PROJECT
RYLANDS BUILDING, MANCHESTER

TITLE
COMPARISON PLAN TENTH FLOOR - NON MATERIAL AMMENDMENT

JOB No	DWG No	REV
1526	AL[05]2223	*

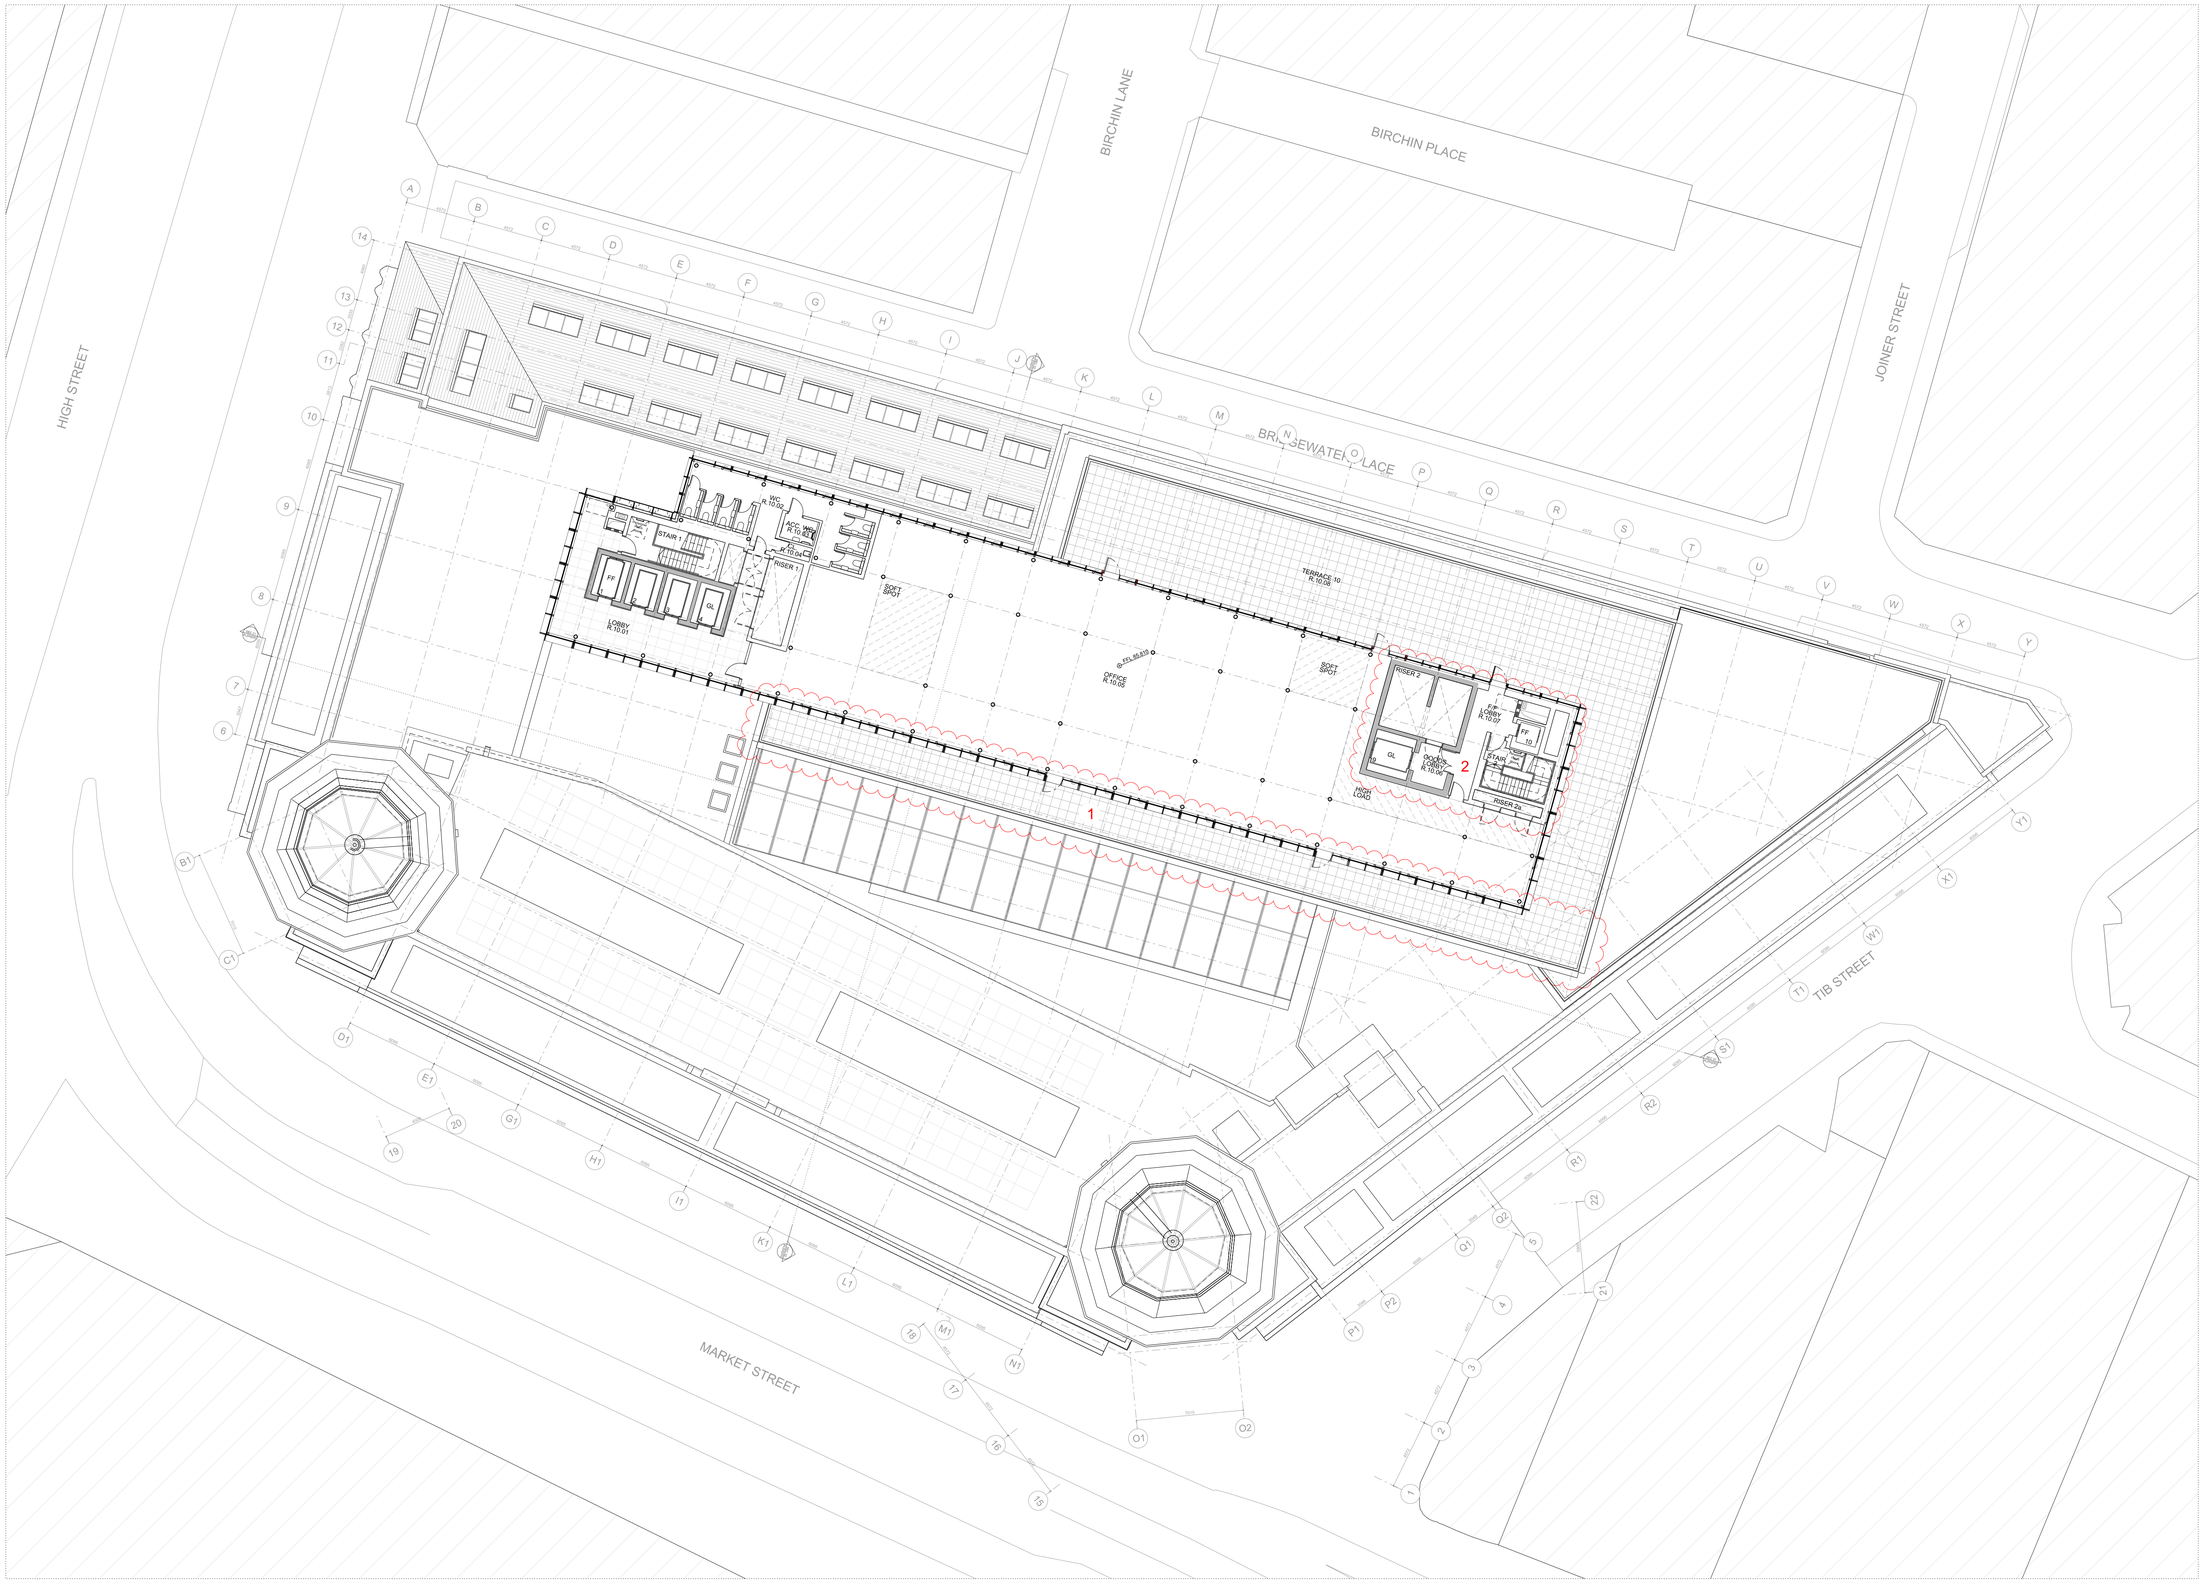
1. Creation of a south facing terrace to respond to change in plan form below and mitigate increase in building height.

2. Stair core 2 arrangement updated to reduce works to existing staircase to lower floors and provide additional goods lift.
